NAME The Surveyors,

Dated 6.8.51 Received 13.8.51 Answered .....

Vessel's Name : ~~X~~ "NICHIEI MARU"

With reference to your Classing Letter of 24th instant, we have to state in reply to your questions as follows:-

Bilge Suctions

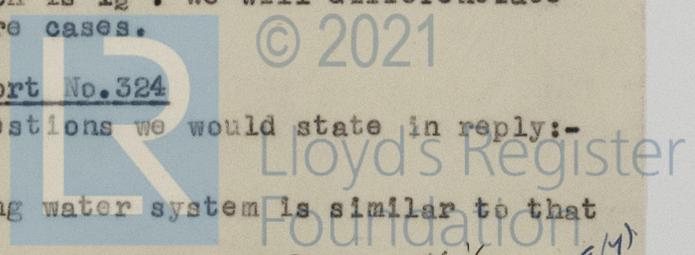
We regret that the bilge suction in machinery space as given in the report are misleading, but are according to the approved plan except, that we made a mistake in the condensate pump recess suction in stating that it was 1 1/2". This should be 2". It is the hand pump suction which is 1 1/2". We will differentiate between the two systems in future cases.
